# **Report and Resolution**

**Community Board 7/Manhattan**  
**Under the Uniform Land Use Review Procedure**

## **Riverside Center**

**July 2010**

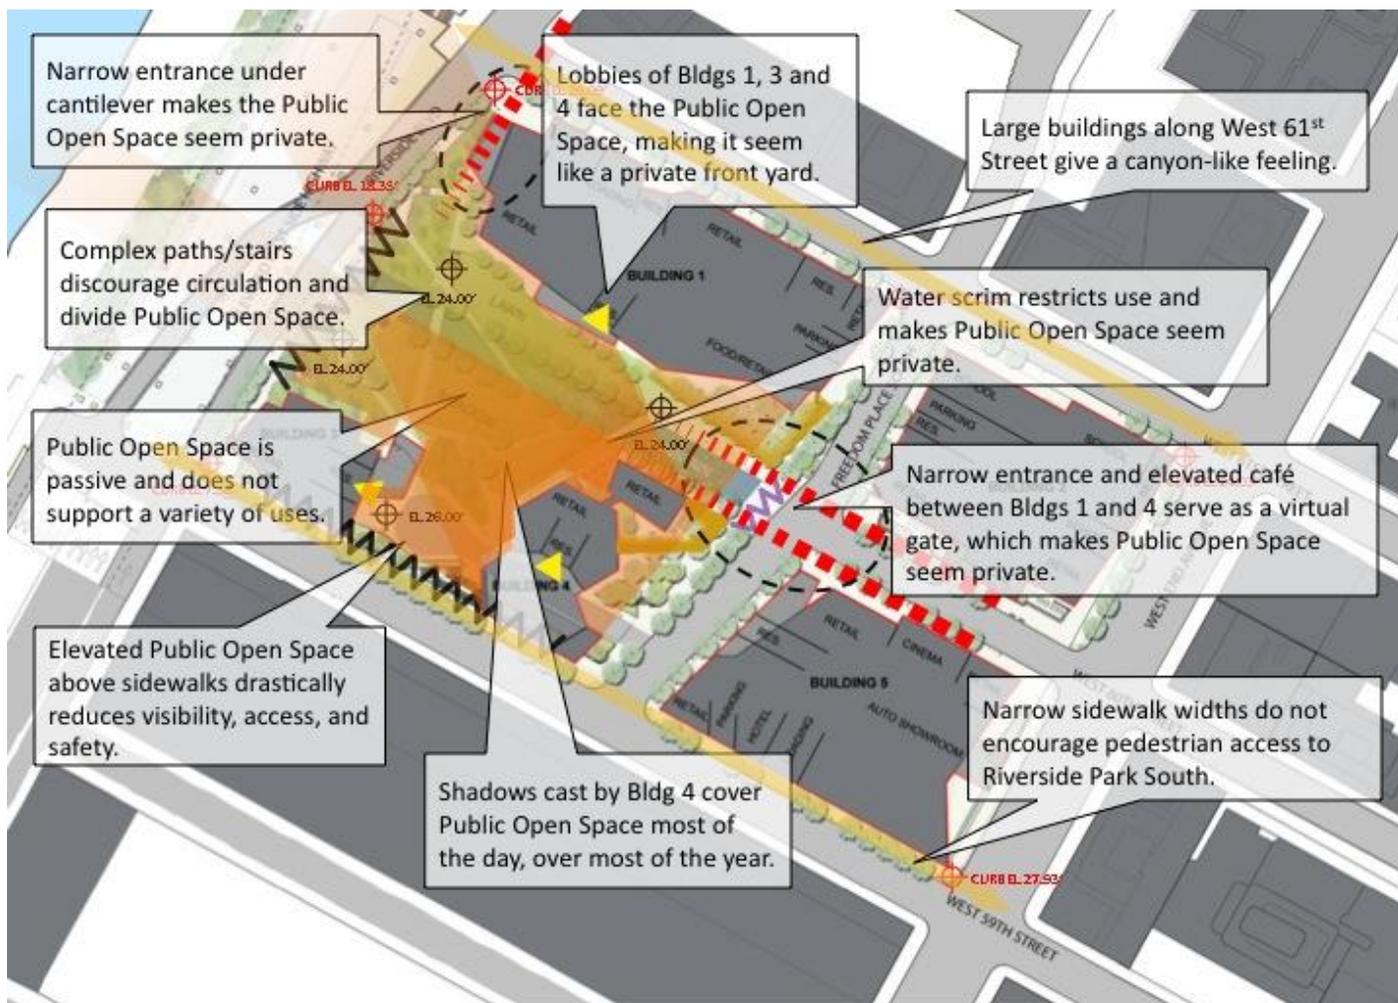
*MCB7 recommends removing Building 4 to dramatically expand useful Public Open Space, provide for active recreation, reduce shadow and wind, provide a central open area for the Development, and open connections to the historic powerhouse to the south.*

*MCB7 recommends “straightening” Freedom Place South to expand the Public Open Space, reinforce the city grid, and provide visual perspectives of the historic powerhouse.*

*MCB7 recommends modifying the footprint of Building 5 to accommodate the “straightening” of Freedom Place South to expand Public Open Space, further reduce density, reinforce the city grid, and provide visual perspectives of the historic powerhouse.*

## MCB7 Recommended Modifications

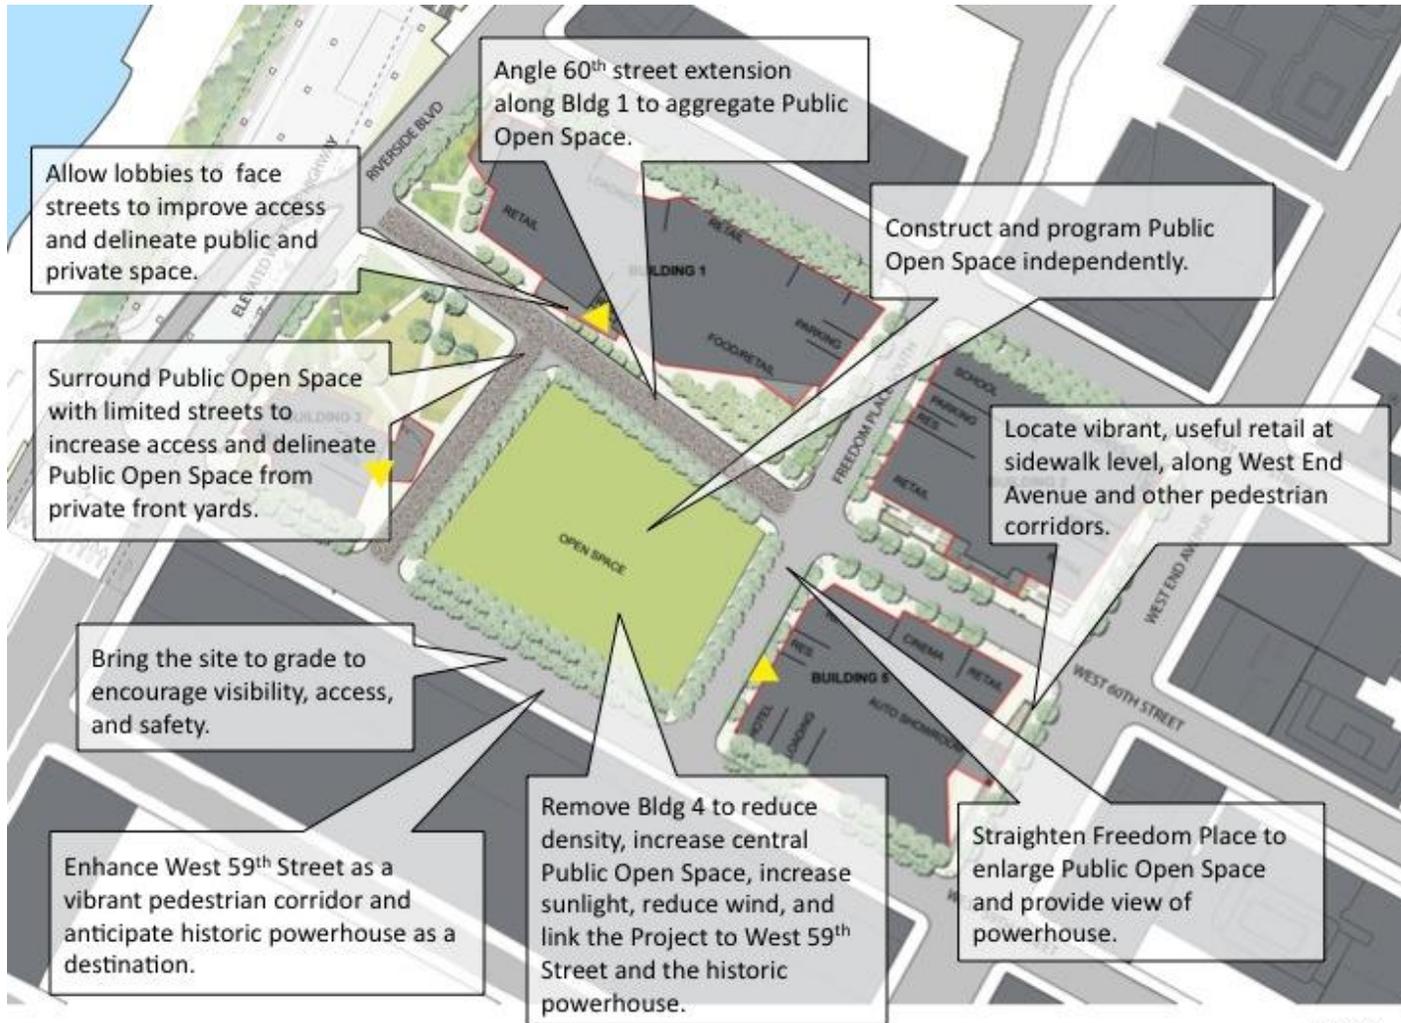
*MCB7 recommends eliminating the private driveway that serves Building 3 to expand Public Open Space and reinforce the city grid.*

### 3. Street Rationalization

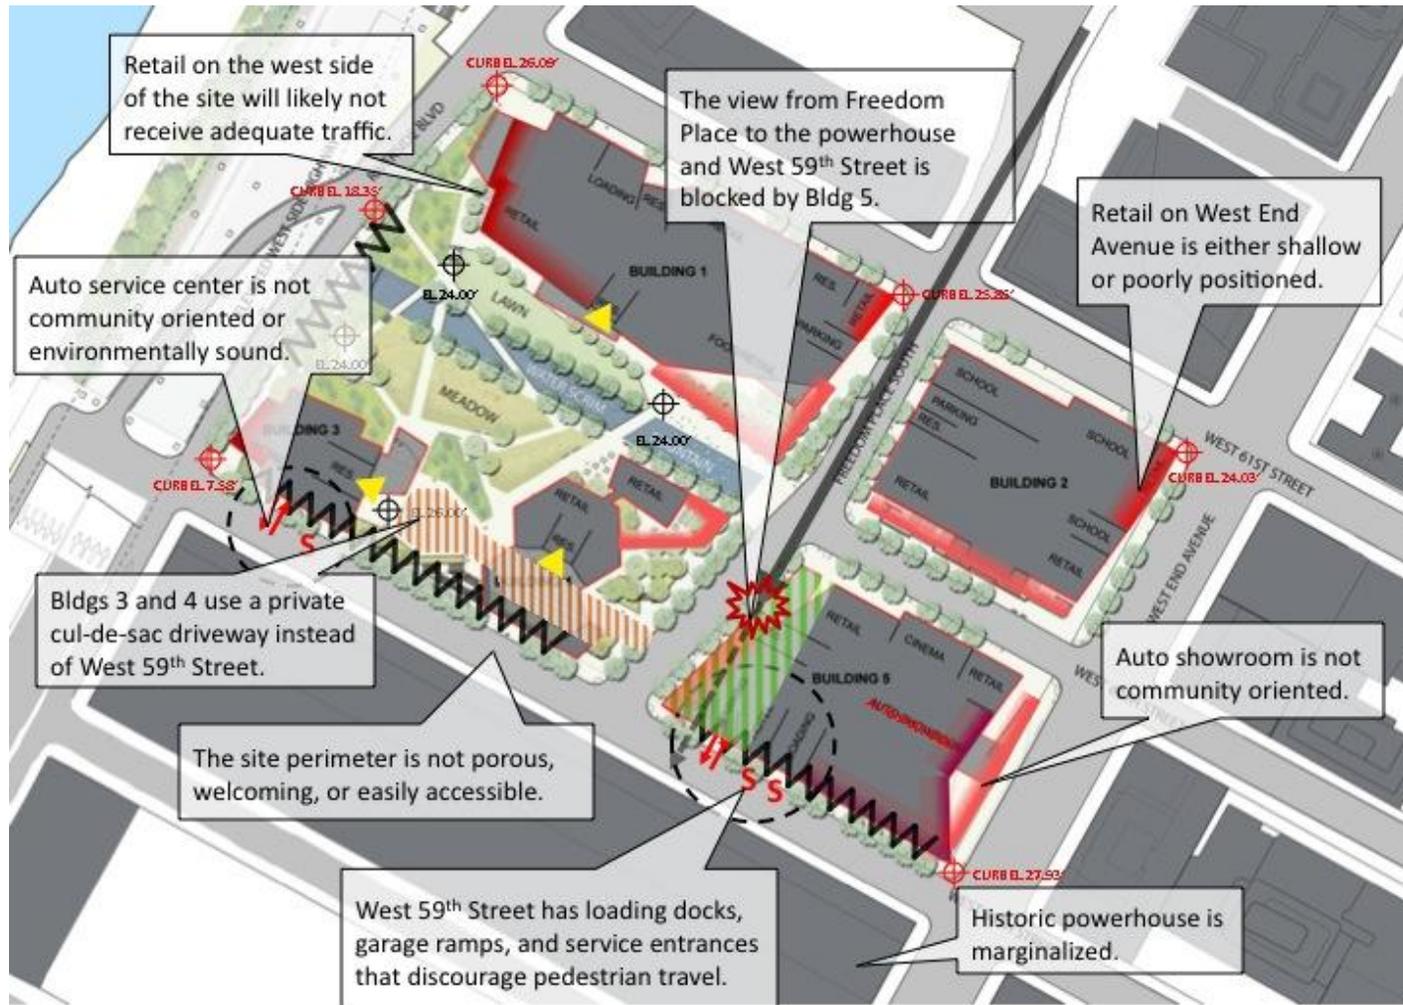
The DSEIS recommends that West 59<sup>th</sup> Street become a westbound street to allow drivers to access the site from the east. The 1992 Restrictive Declaration required that West 61<sup>st</sup> Street become a westbound street, but NYC Department of Transportation (NYC DOT) is not considering this.

Additionally, NYC DOT has decided to install a pedestrian refuge island at West 61<sup>st</sup> Street and West End Avenue and prohibit left turns into Riverside Center from northbound West End Avenue. This means the only access onto West 61<sup>st</sup> Street between West End Avenue and Riverside Boulevard will be from the north. Given that West 61<sup>st</sup> Street will be a primary roadway into the site, and the 8-year construction plan calls for trucks to be allowed to make this left turn, MCB7 believes the island should be moved to West 62<sup>nd</sup> Street.

*MCB7 recommends that the pedestrian refuge planned for West 61<sup>st</sup> street and West End Avenue be moved to West 62<sup>nd</sup> Street and West End Avenue.*
